**Item 4.****Development Application: 698-704 George Street and 43-57 Goulburn Street Haymarket**

File No.: D/2017/1787

**Summary**

**Figure 8:** The amended concept envelope. Note the introduction of the splayed overhang on the north elevation fronting Goulburn Street starting at level 22

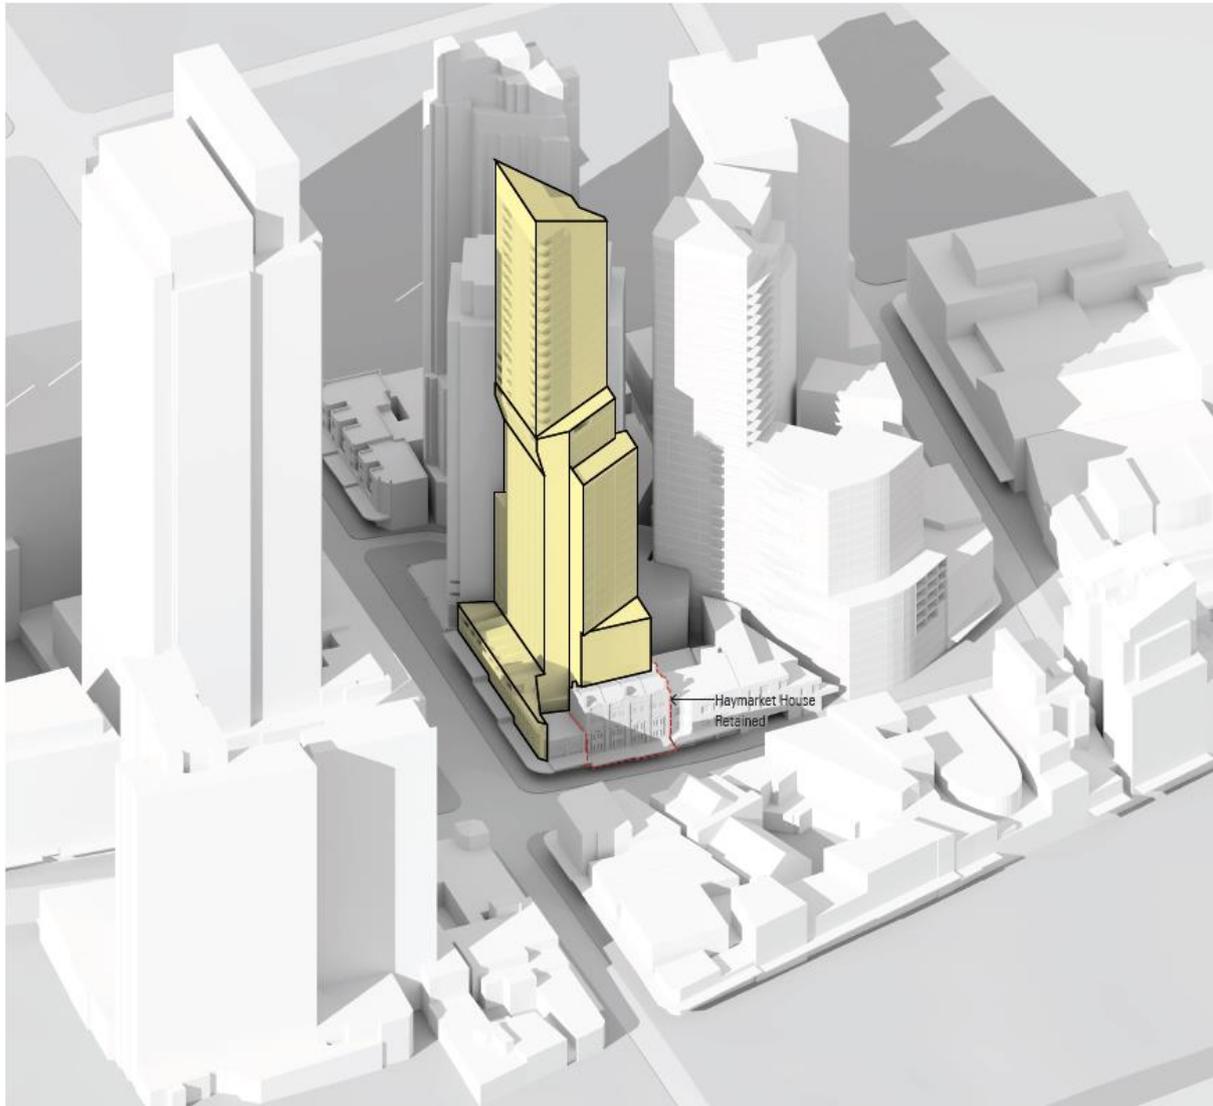
The amended plans show the redistribution of floor space to the northern elevation above level 22 due to an upper modified setback to Goulburn Street reducing from eight metres to six metres. Although this represents a non-compliance with the setback controls under Section 5.1.2 and 5.1.3 of the Sydney Development Control Plan 2012 in this case the high level departure from the control is acceptable as the development will not adversely impact the amenity of neighbouring properties, will not have an unacceptable urban design outcome and, subject to further investigation at the detailed design stage, will not result in adverse wind impacts to the public domain.

- (a) The building envelope incorporates a series of chamfered setbacks on the western elevation to improve solar access to the adjoining Inmark tower.

- (b) A gradual modulation to the façade (over three stories) reducing the Goulburn Street setback from 8 metres between the podium and level 21, to 6 metres from 24 and above.

- (c) The height of the podium adjacent to no. 694-696 George Street has been raised from two storeys to three storeys, forming a consistent street wall height on Goulburn Street.

Figure 12: The amended building envelope with shadows cast at 1pm midwinter.

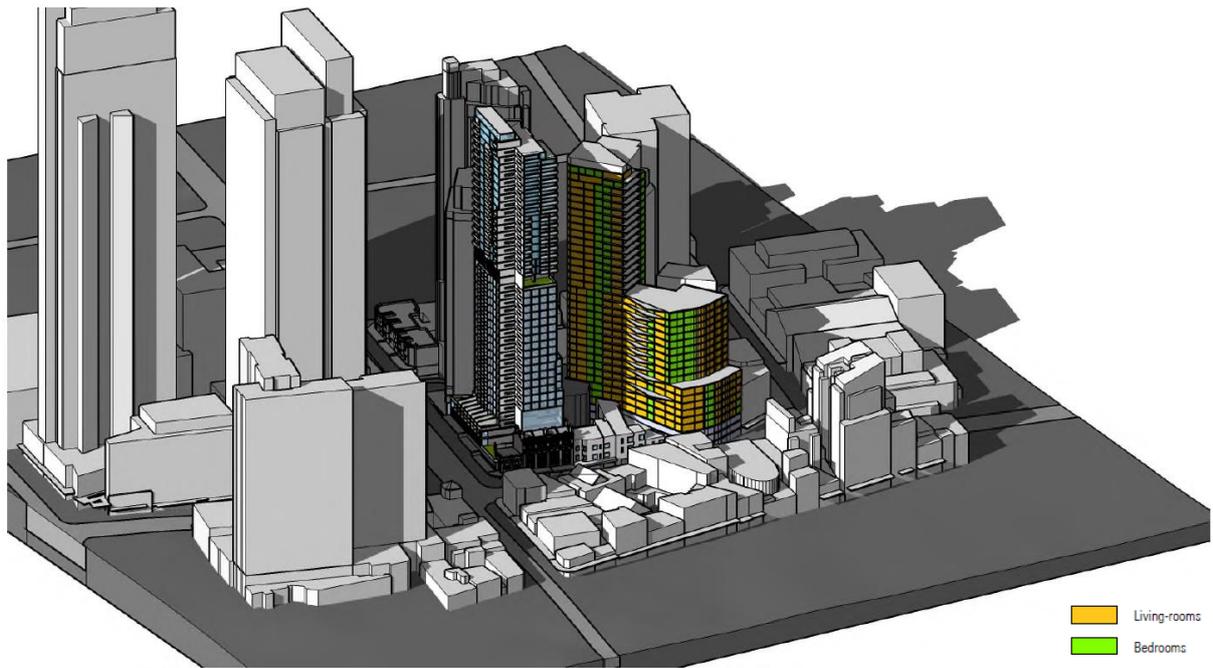
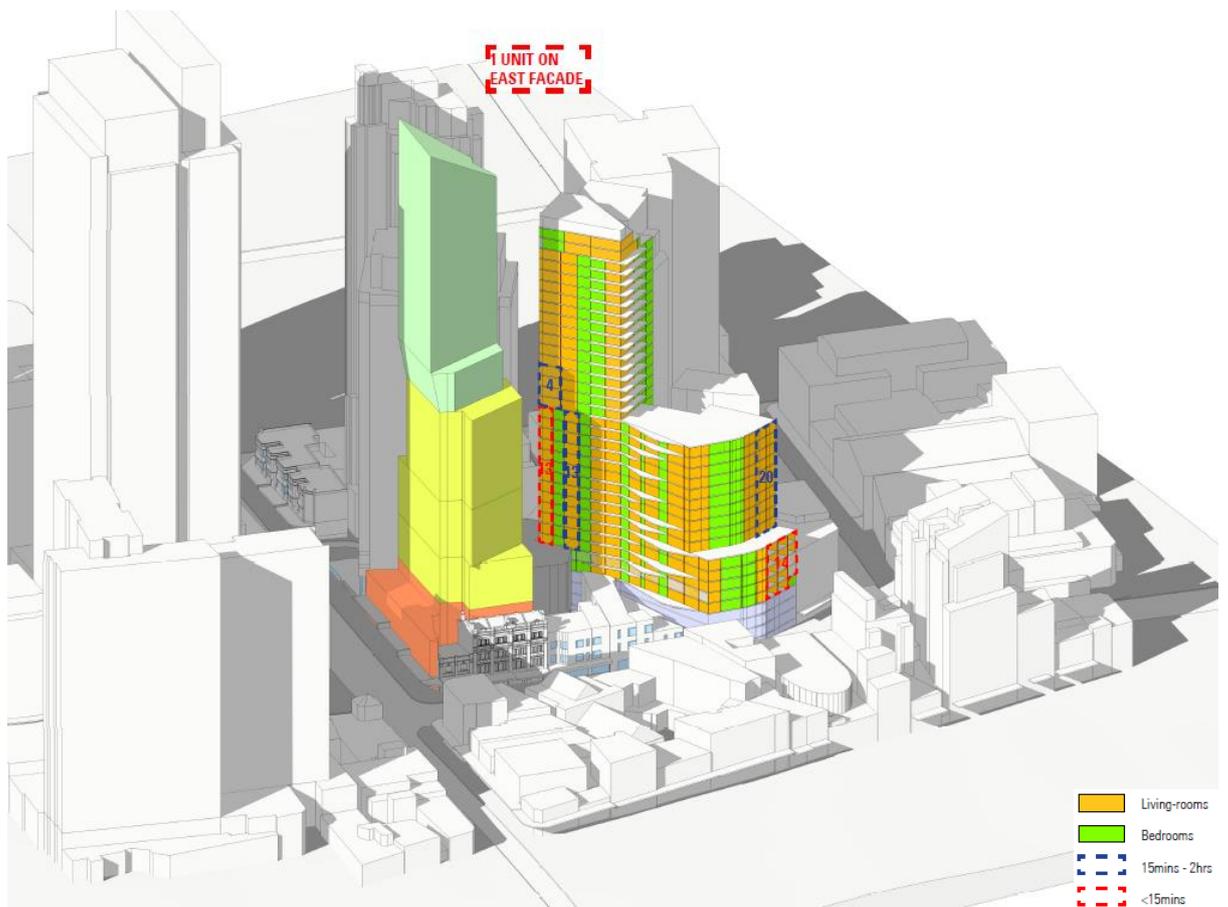
34. The proposed building envelope has been amended so that 70% of apartments (160) within the adjoining Inmark residential apartment building receive at least 2 hours solar access to living rooms and balconies, a reduction from 183. The number of apartments receiving no direct solar access will increase from 15 (6.9%) to 28 (12.8%), compliant with the design criteria. The development will not adversely impact solar access to other nearby apartment buildings as discussed in the previous assessment report at Attachment C1.

35. The fact that the proposed development will overshadow an additional 13 apartments which currently receive more than 2 hours solar access to living rooms and balconies is not a direct product of the proposed building envelope but rather results largely from the design and orientation of the existing Inmark building, which relies on amenity borrowed over the subject development site. These apartments are located deep within the block and within the lower half of the tower. While the impact to the amenity of these apartments is acknowledged, it is unreasonable to protect their solar access and thereby sterilise this prominent inner city site from redevelopment. The amended design, which is compliant with the maximum height, FSR and relevant objectives of the ADG, is therefore a fair and reasonable redevelopment of the site and is supported in its amended form.

**Figure 14:** Simulation of existing and proposed views from unit 35b. The extent of the non-compliant setback to Goulburn Street is shown in yellow.

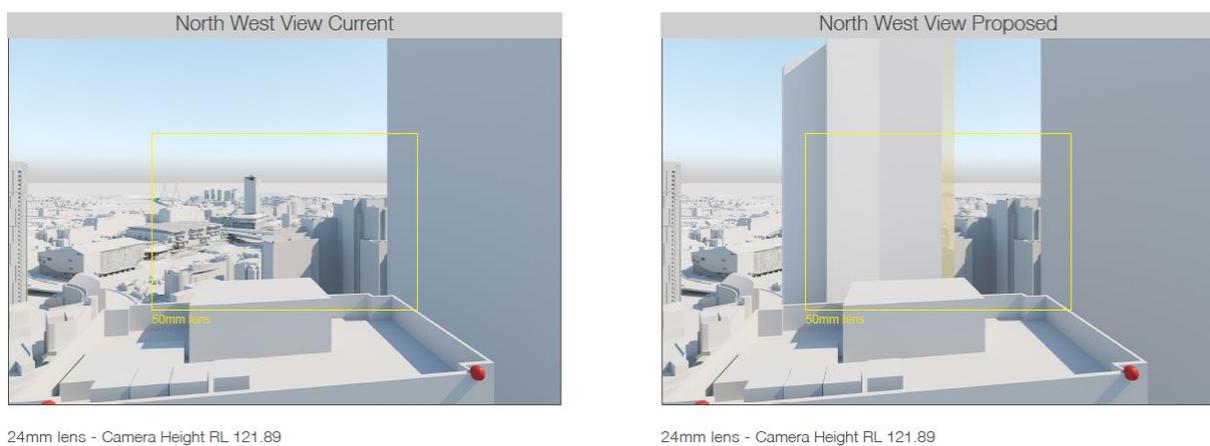
38. The amended building envelope proposes to reduce the setback to Goulburn Street above level 22 from eight metres to six metres. The applicant was requested to provide an additional view loss assessment as a result of the proposed modification to determine whether the proposed envelope would adversely impact views from no. 2 Cunningham Street. As such, this assessment considers the view loss which would result from the additional bulk fronting Goulburn Street.

43. The extent of the impact is assessed on a qualitative, rather than quantitative, scale. As shown in the figures below, the non-compliant setback to Goulburn Street would have a marginal impact on views to the west, with district views and, for the penthouse and other northwest apartments, views to Blackwattle Bay and the ANZAC bridge retained. The impact of the non-compliance is therefore considered negligible to minor.

44. The view impact analysis provided with the amended plans is acceptable and demonstrates that the development would have an acceptable impact with regard to views as established in Tenacity.
